CITY OF DOVER

PLANNING TECHNICAL REVIEW COMMITTEE –AGENDA

1. 10:30 AM – 11:15 AM: Site Review for JSR, LLC., Assessor's Map D, Lots 11-5 & 11-5SND, zoned IT & Wetlands Protection Districts located at Quality Way and Venture Drive. (Proposal is for construction of a 10,080 s.f. Contractor Storage Bay/Office facility consisting of four (4) separate bays with office space.) A CUP and LLA will also appear before the Planning Board. (P22-55/SITE-2022-0011) [*Previously heard on August 11, 2022*]

Re: Site Plan Review
Berry Surveying & Engineering
JSR, LLC
Venture Drive & Quality Way
Tax Map D, Lots 11-5 & 11-5SND
Dover File #P22-55

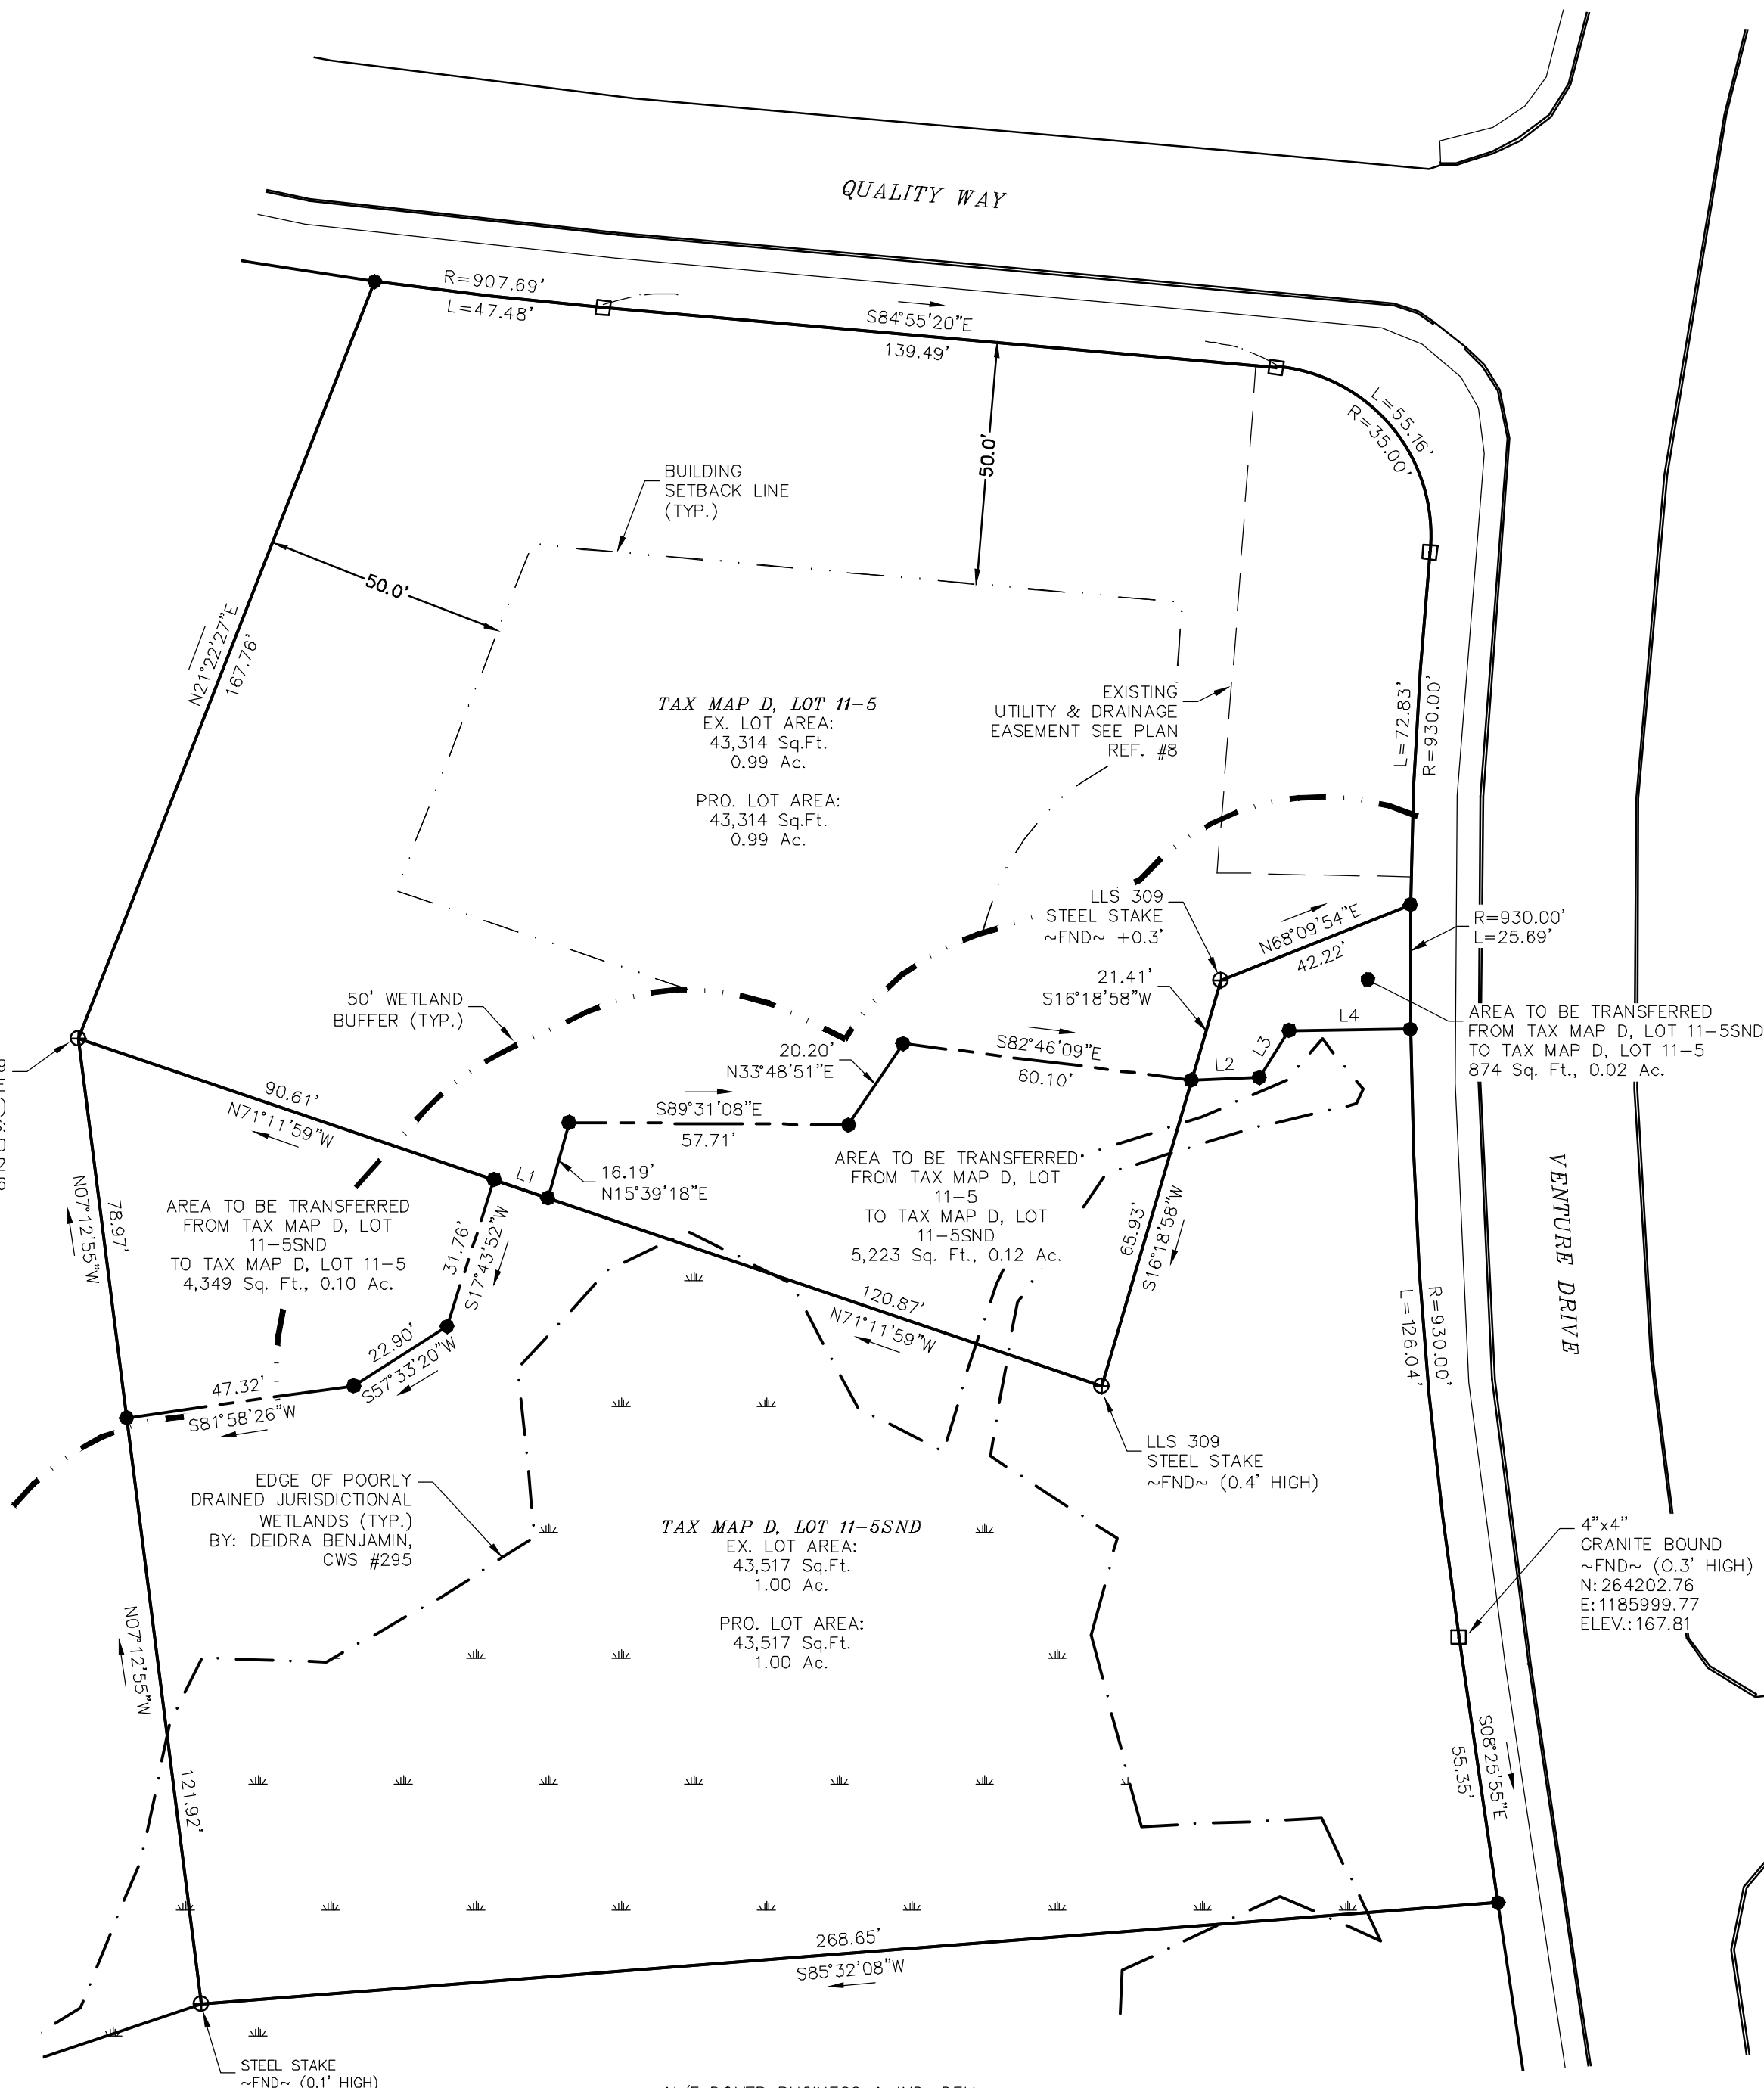
- 1.) General Note: Add note to reflect that an easement is provided to the City to maintain the potable drinking water quality through the hydrant flushing program, which includes providing access to the water curb boxes.
This has been added as note #9 on the Lot Line Revision, sheet #4.

EASEMENT PLAN
LAND OF
JSR, LLC
VENTURE DRIVE & QUALITY WAY
DOVER, NH
TAX MAP D, LOT 11-5 & 11-5SND

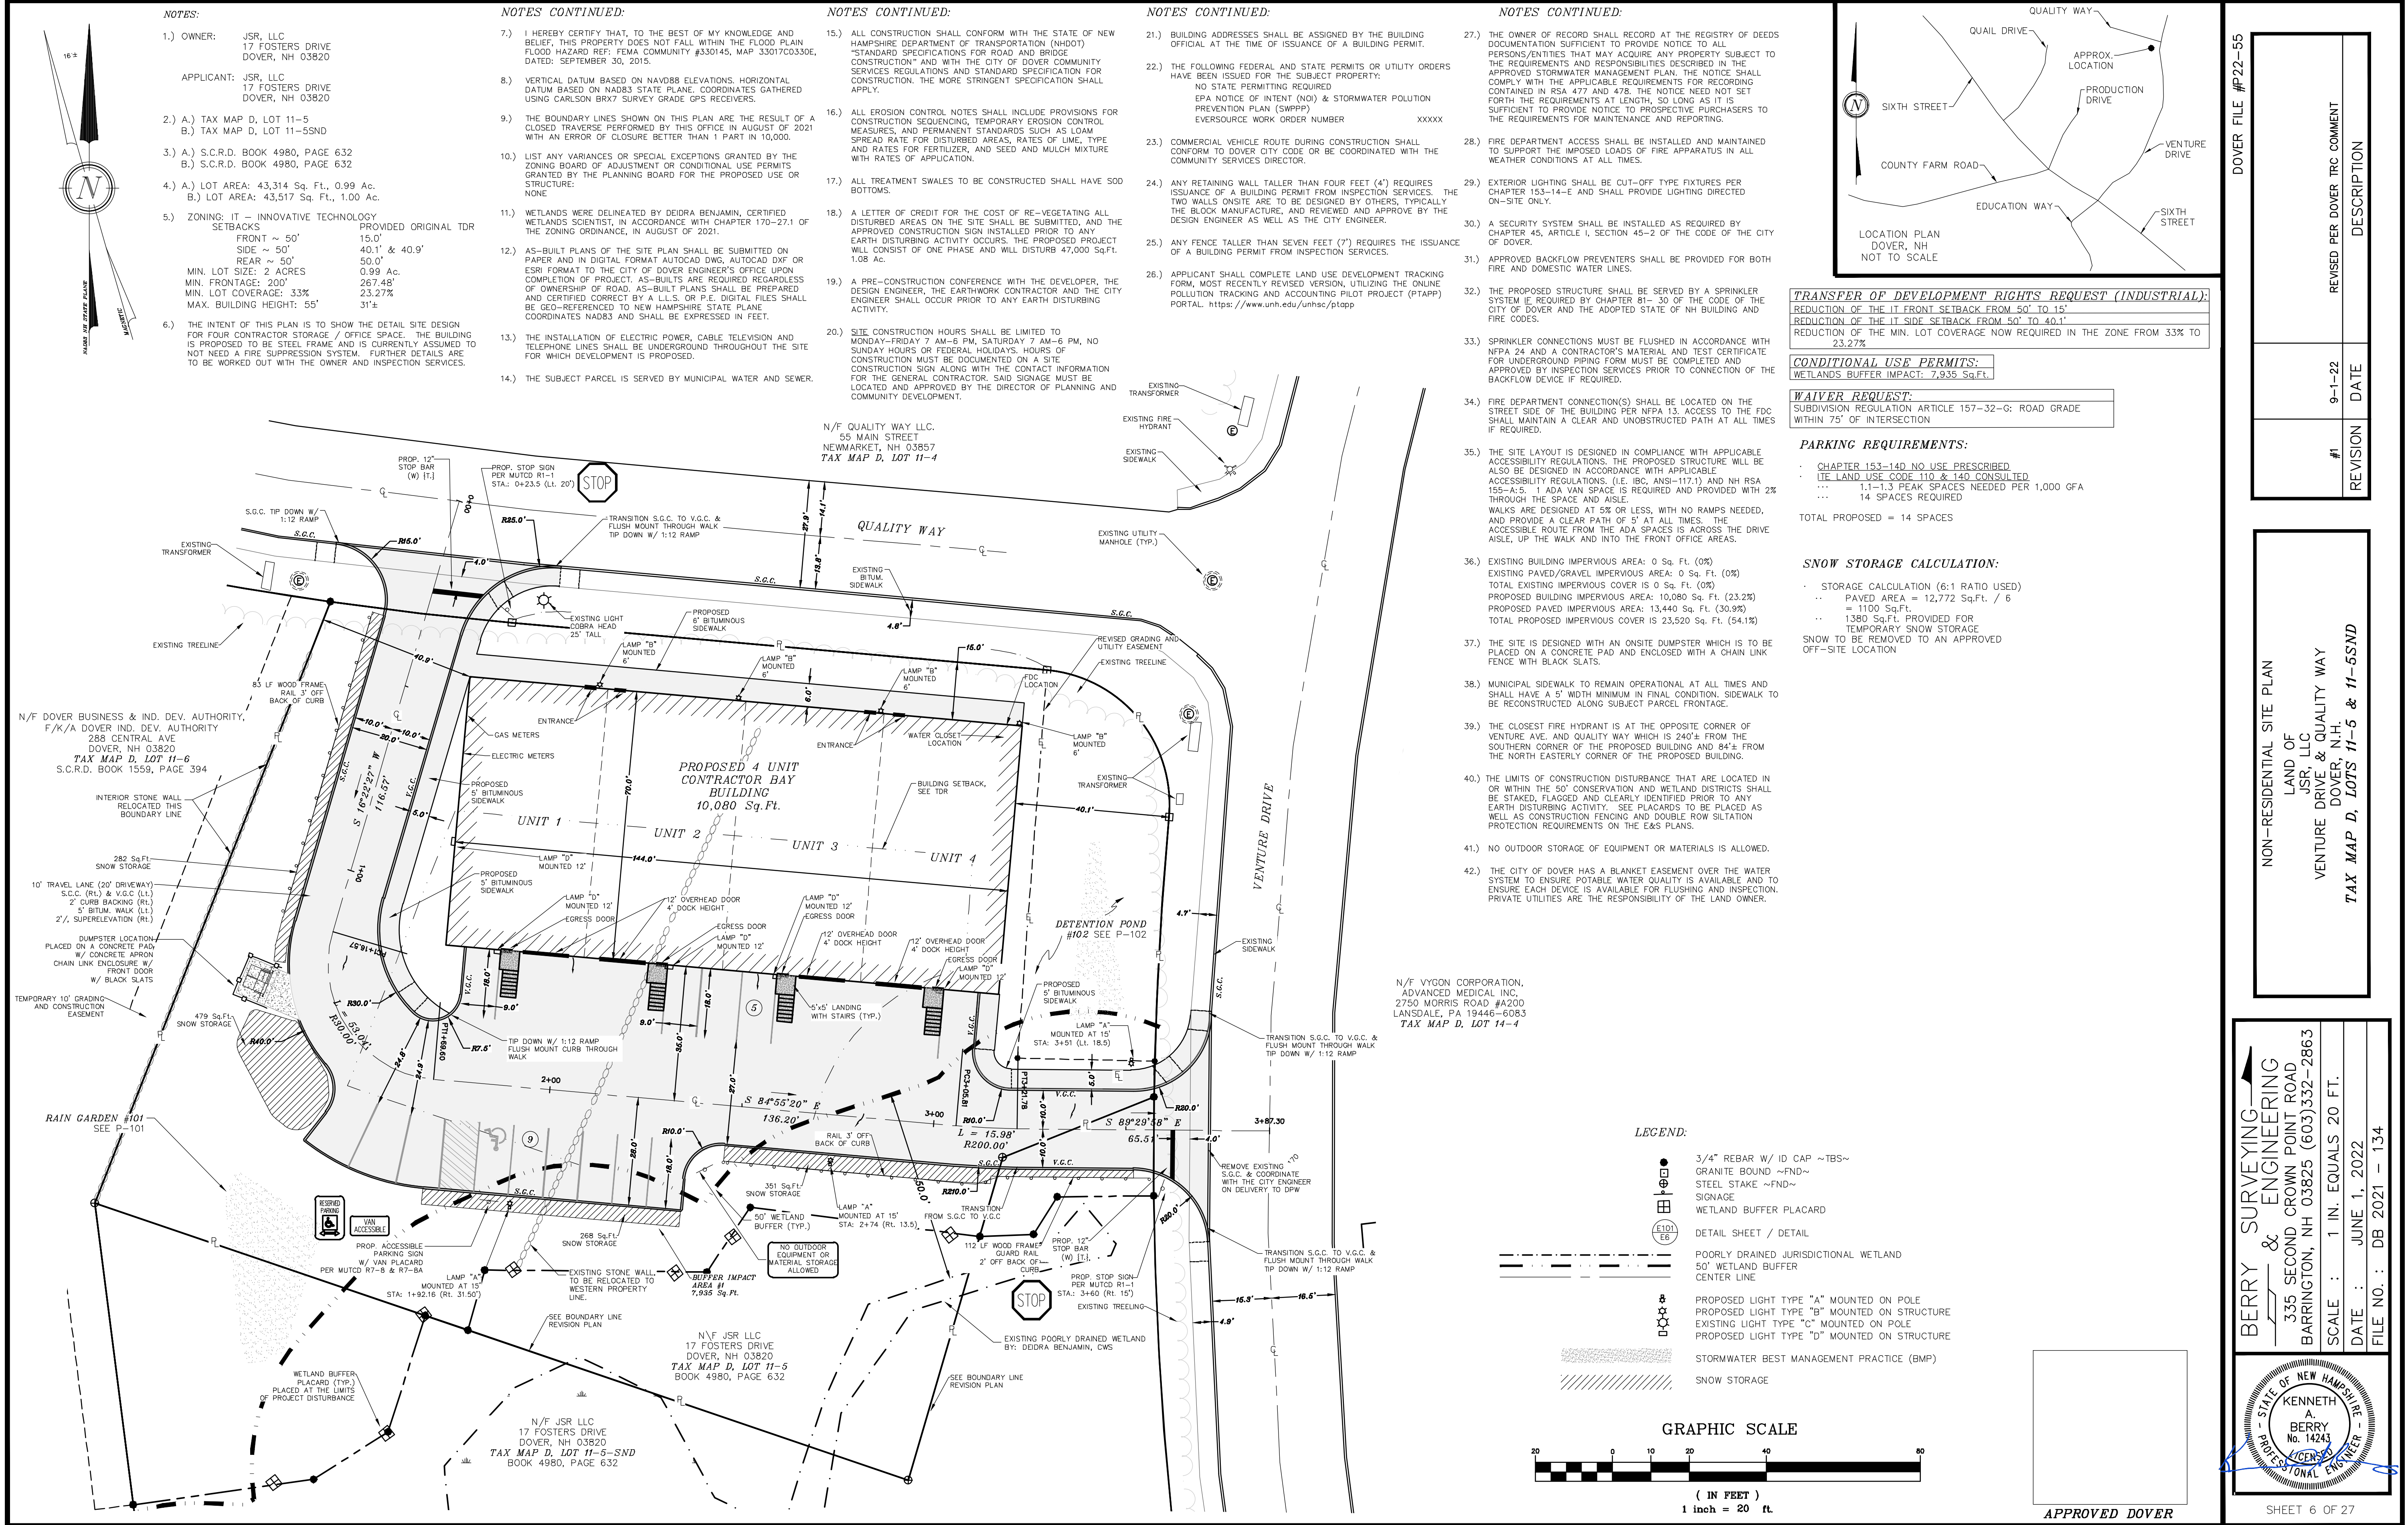
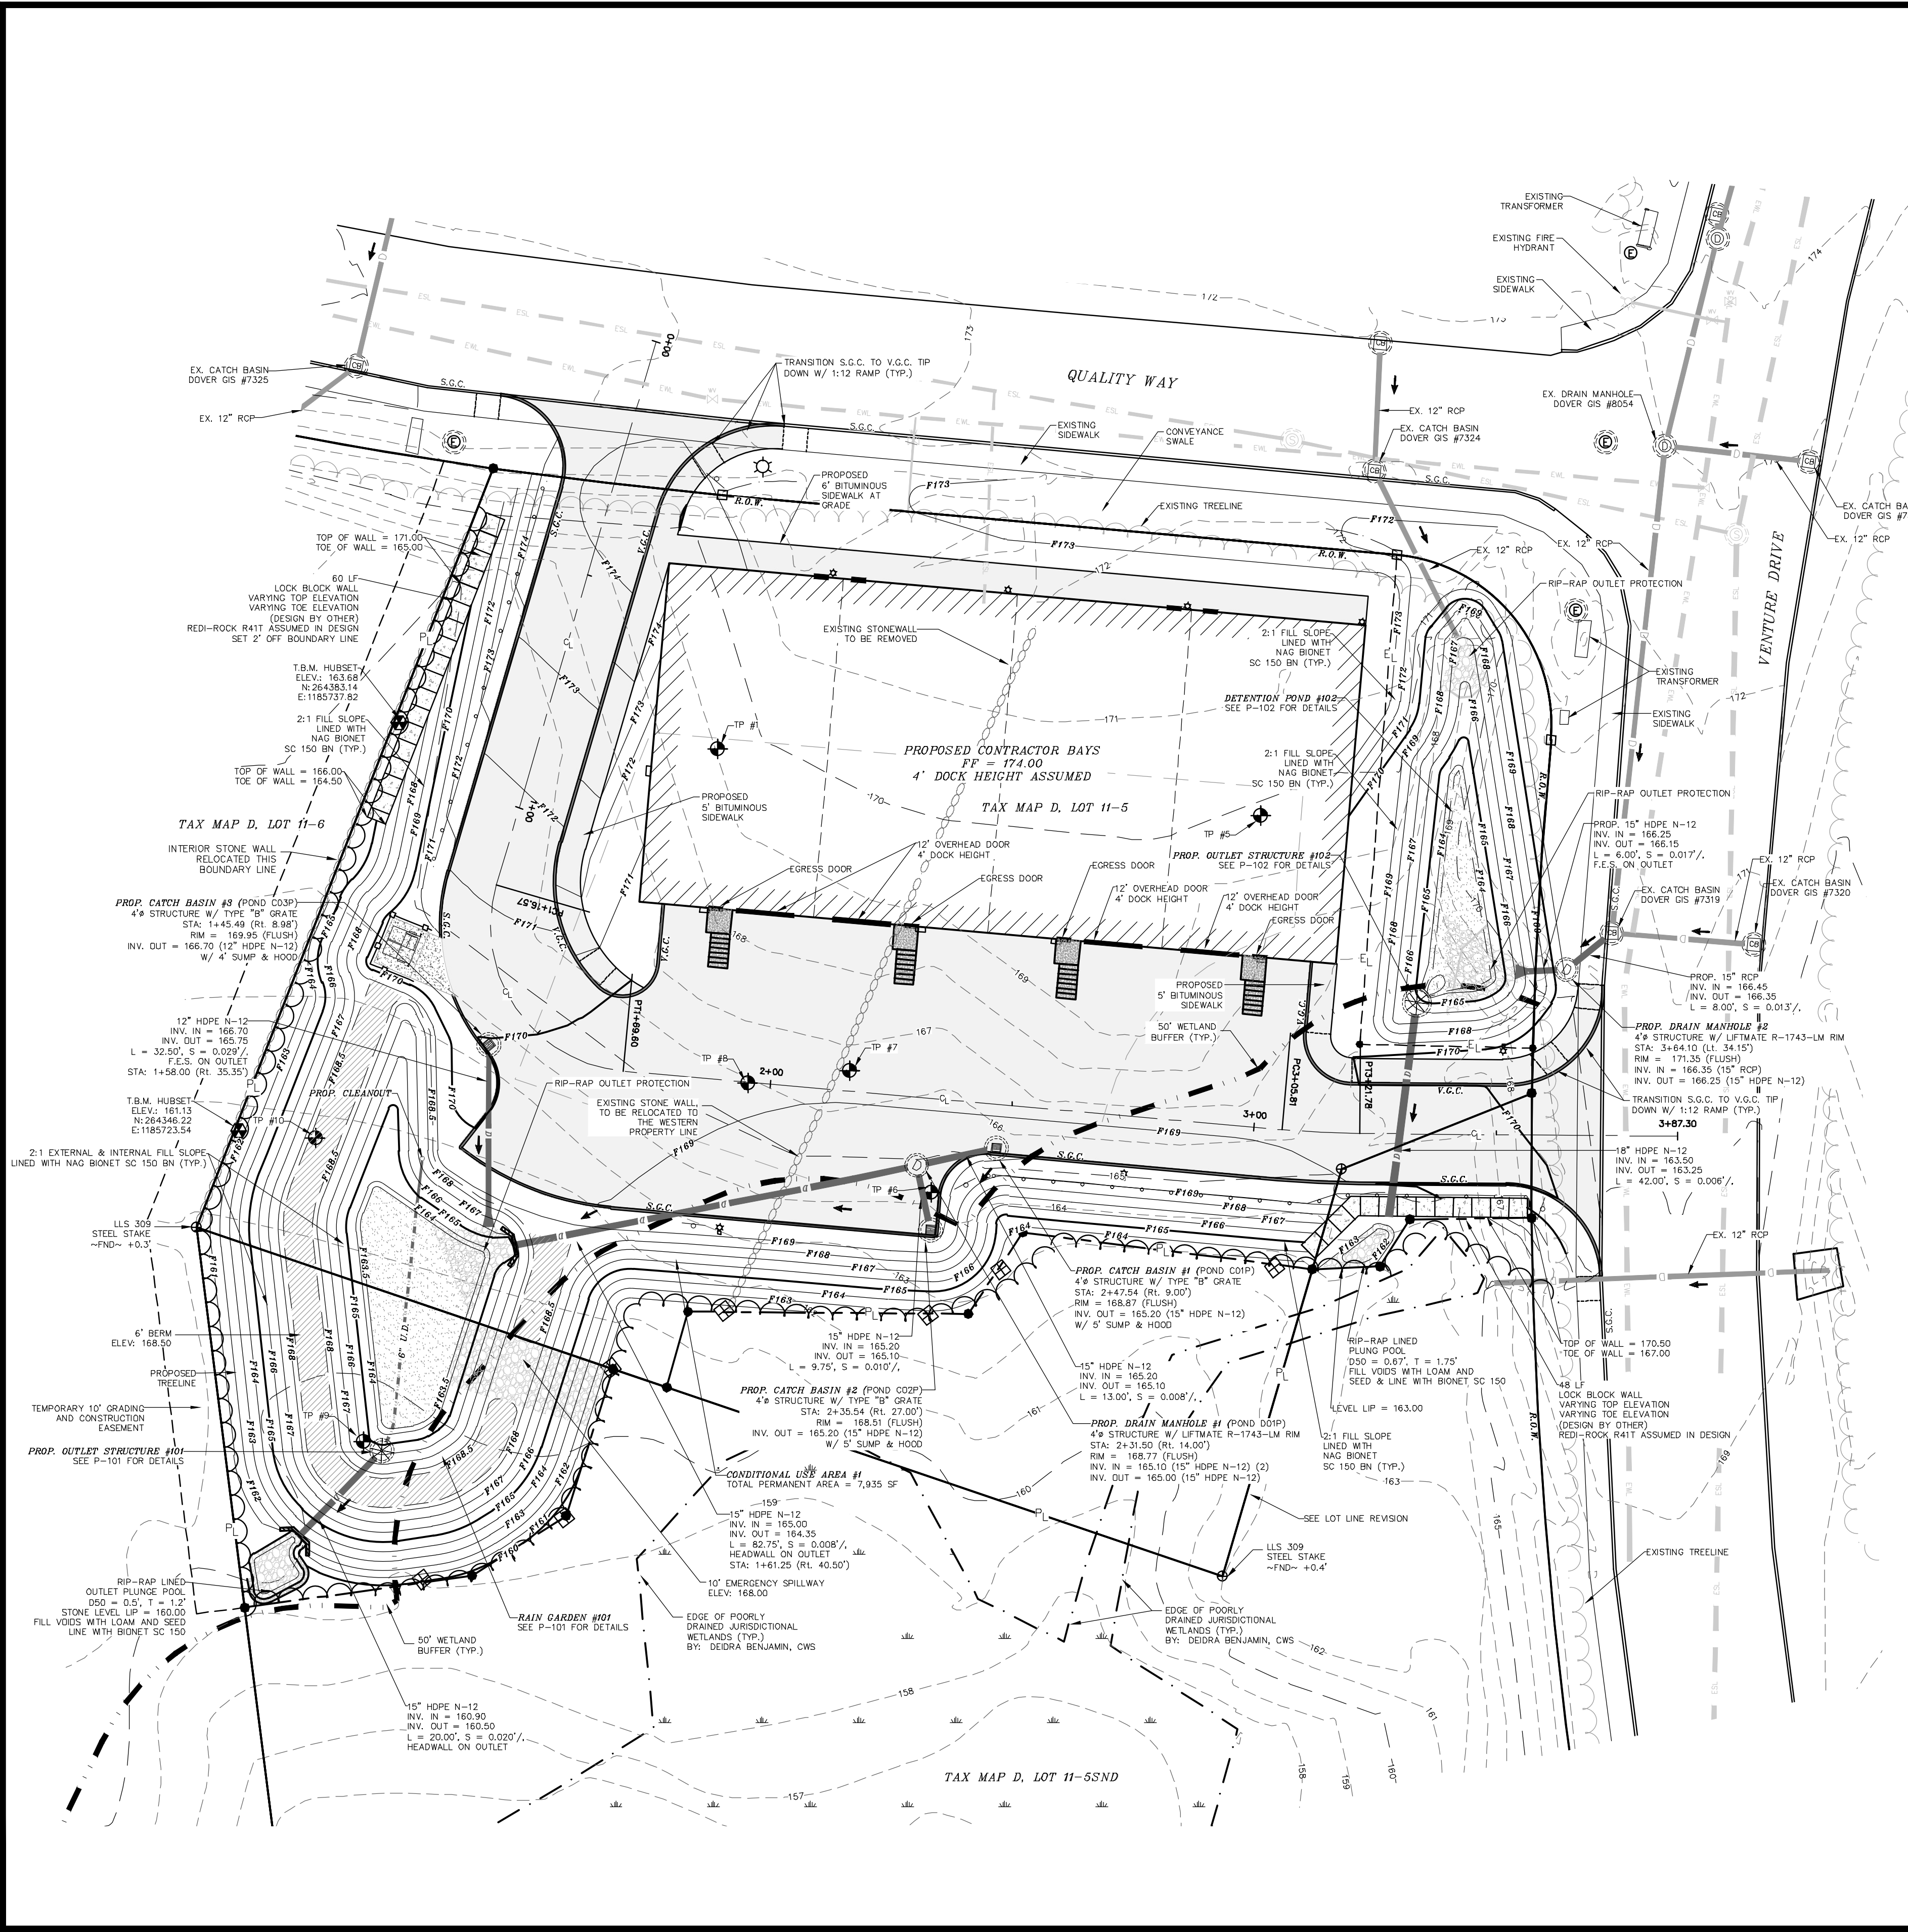
3. Sheet 6: Grading is within 5' of property line; clarify if an easement will be required from adjacent property.
A temporary grading easement is now proposed with the DBIDA with the shown on the Easement Plan, sheet #5. Easement plans were sent to the Assistant City Manager for review and comment.

4. Sheet 6: Applicant shall verify if sufficient spaces is provided to construct the block wall or if an easement is required.
A temporary grading easement is now proposed with the DBIDA with the shown on the Easement Plan, sheet #5. Easement plans were sent to the Assistant City Manager for review and comment.
